Product / Process Change Notification (PCN)

PCN #: PCN_ConCIRCM12_20240303

Affected Series: WR-CIRCM12 -643452100308

For part number: 643452100308

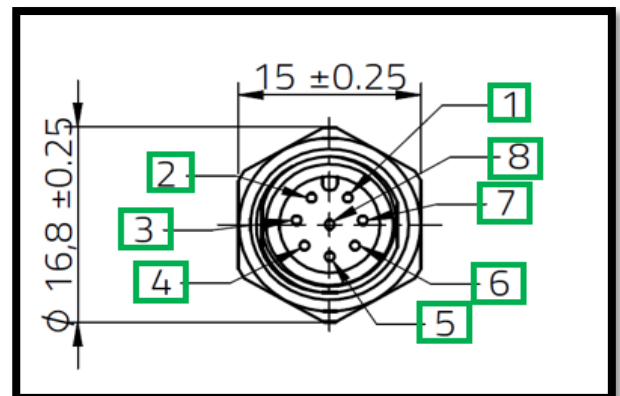
As a datasheet information amendment, Würth Elektronik will correct the pin numbering of the product 643452100308. This is a datasheet correction only. There will be no change in form, fit, function, quality or reliability of the product.
